Subject: N182206500 - Service Update
Hood Ball Stud Bracket is Not Zinc Plated

Models: 2019 Cadillac CT6

N182206500 Hood Ball Stud Bracket is Not Zinc Plated

5286412

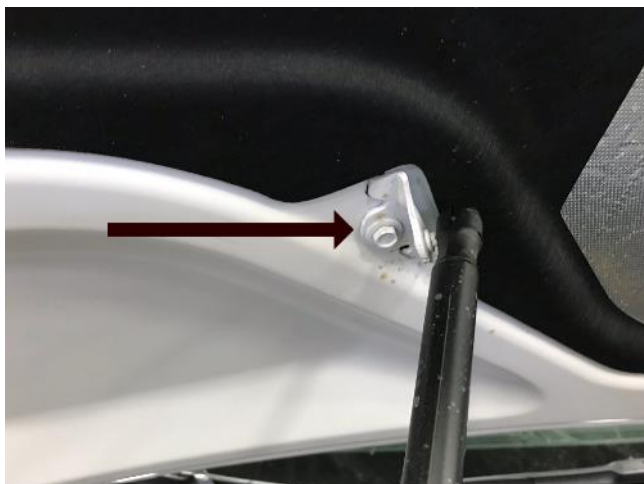
Condition	Certain 2019 model year Cadillac CT6 vehicles were built without required protective metal coating on the hood ball stud bracket. Over time, metal to metal contact may create a corrosion issue in which the ball stud bracket used to anchor the hood could cause visible rust.
Correction	Dealers are to replace the hood ball stud bracket.

3. Disconnect the hood struts at the hood stud ball brackets. Refer to *Hood Strut Replacement* in SI.
4. Remove the hood stud ball bracket bolts and brackets and discard.

5. Install the new hood stud ball brackets and bolts and torque to 10 Nm (89 lb in).
6. Connect the hood struts at the hood stud ball brackets. Refer to *Hood Strut Replacement* in SI.
7. Remove the hood support.
8. Remove the fender covers and close hood.
